# Product Change Notification

Date Issued :	August 14, 2023	PCN Number :	514114
Reason for Change :	Change to Product		
Description of Change :	This notification is to inform you that Molex or (Molex Supplier) will be making one dimension 1.50 removed in sales drawing of the part(s) listed in this notice, No changes will be made to product as part of this change.		
Assessment of Change :	No change to parts - Form/Fit/Function		
Planned Implementation Date :	February 14, 2024		
Sample Availability Date:	August 10, 2023		
Internal Molex Qualification Date :	August 10, 2023		
Last date to request Samples by Customer :	August 31, 2023		
Traceability Code Markings / Date :	Date code

2156740051 Revision A

Before Picture

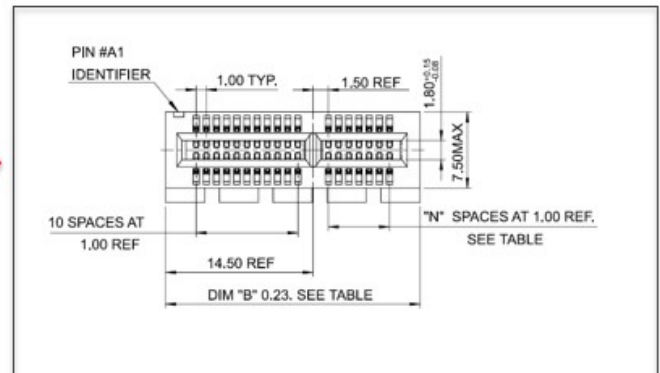
- One dimension 1.50 removed in drawing SD-87715-901
